Plan Review & Routing Comment Form

Project: Auburn Community Commons - Development Plan
Revision: Preliminary
Type: Development Plan
Logos ID: PROJ-PUBLIC - 2020-00000002
Due Date: **Jan 15, 2020**

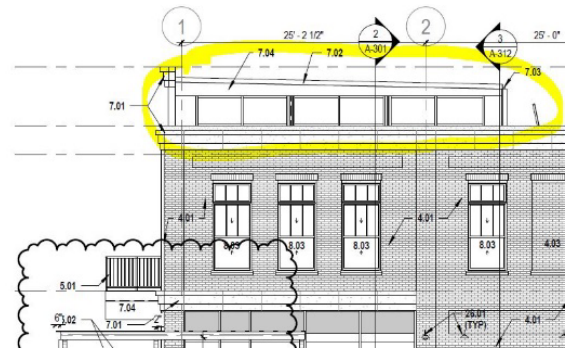
1. Security concerns with opened all day, every day
2. We’d strongly encourage incorporating some sort of storage area within the maintenance space. There always seems to be a need for secured storage areas in downtown.
3. Please consider alternatives to the roof line to allow for natural light and air:
 - Leaving the roof off the open area and designing it to be an open air plaza. It could still have the columns and trusses.
 - Similar to TQS, one portion of the roof being taller than the others with some open air vents (see image)
